Planning Commission Staff Report

MEETING DATE: JANUARY 8, 2020

SUBJECT: DR19-117, COPENHAGEN EAST VALLEY

PROJECT NO.
DATE DECEMBER 17th, 2019
DRAWING TITLE BUILDING ELEVATIONS
DRAWING NO. A302

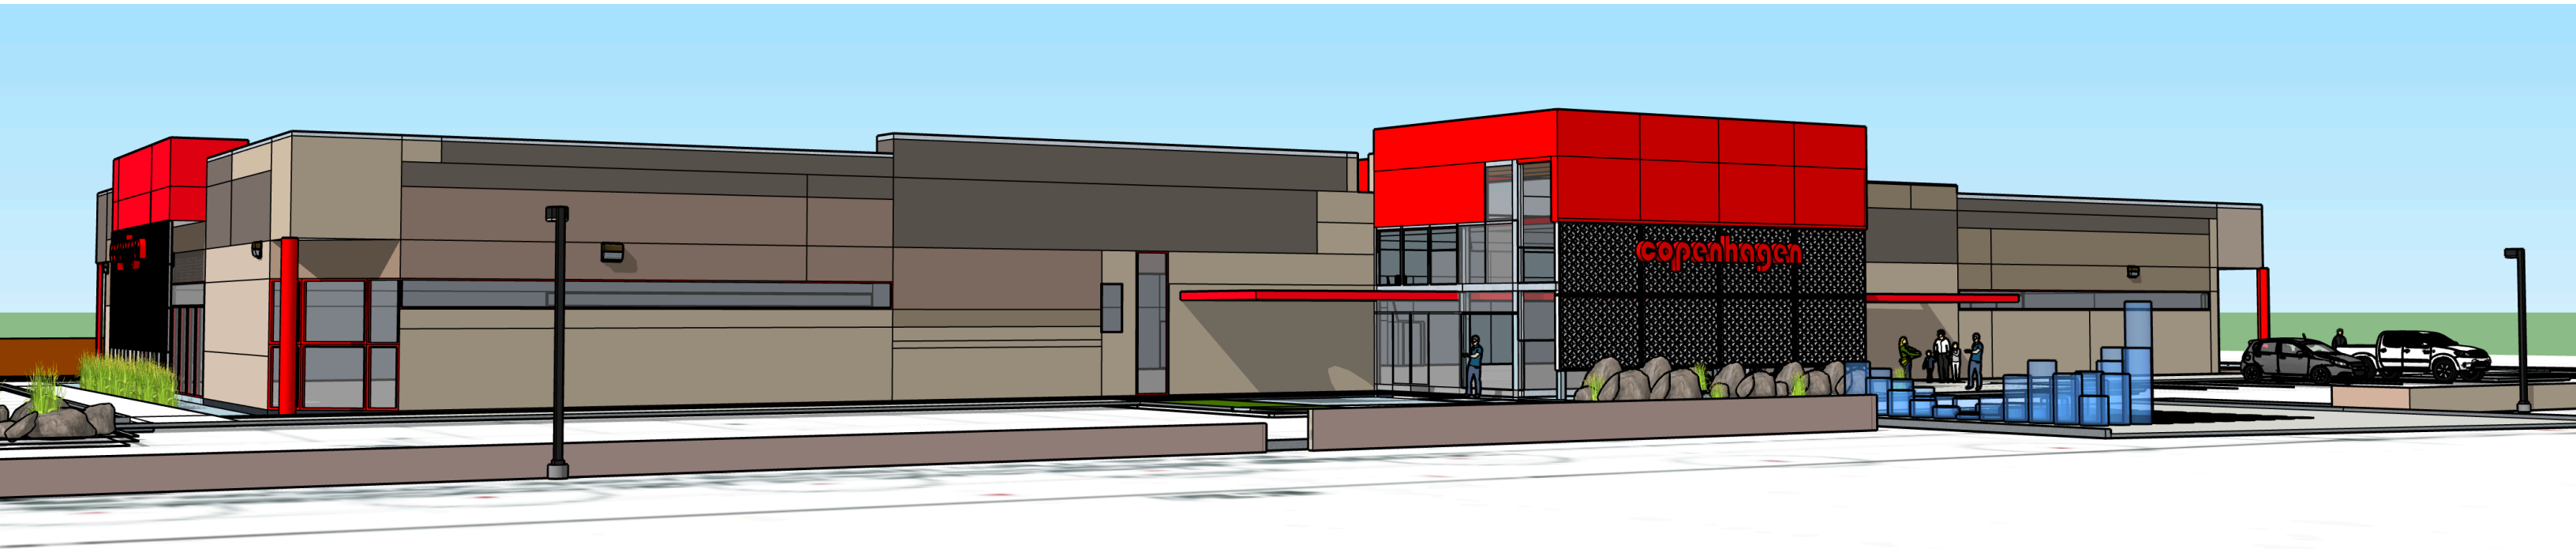
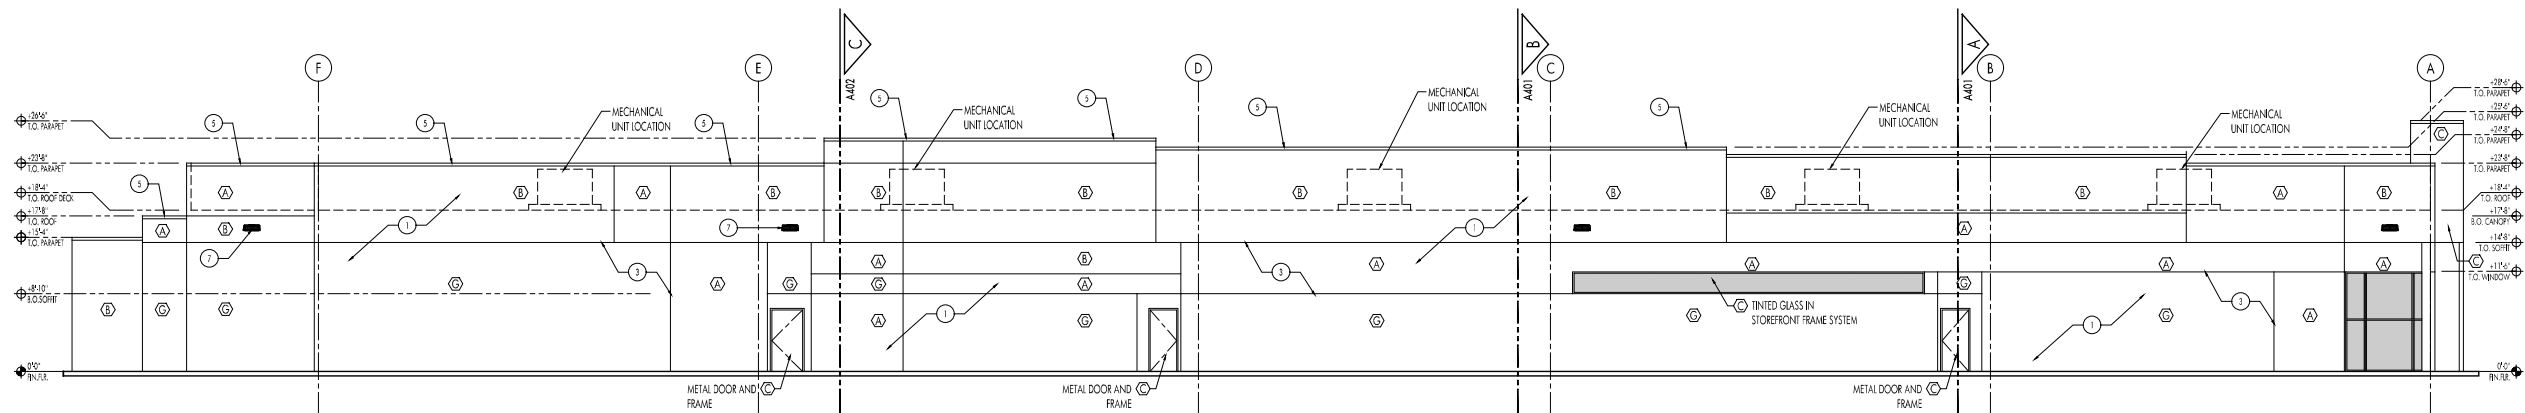
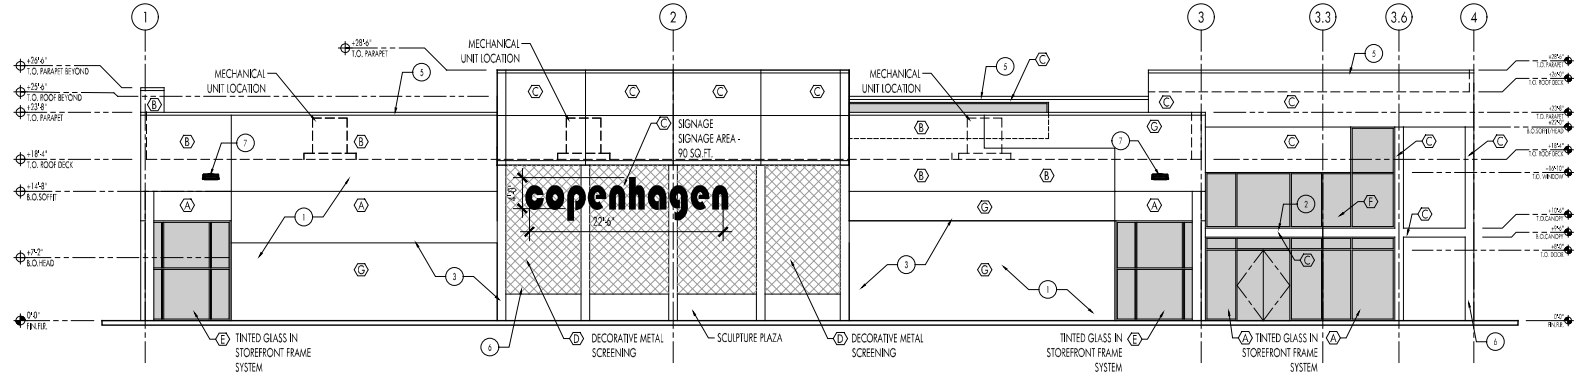
- Commissioners were concerned with the articulation of the building.
 - *The entrance feature parapet height has been raised to enhance the stepping parapet height character along the front elevation. The large awnings flanking the entrance provide pedestrian scale movement to the building. Color blocking has been adjusted and the main entry feature metal accent projection has been carried over to the west elevation to provide further articulation to a previously flat wall. The parapet of this accent area has also been raised to provide further vertical movement. The rear elevation parapet height varies from 1'-3' and rear doors have been recessed into the building.*
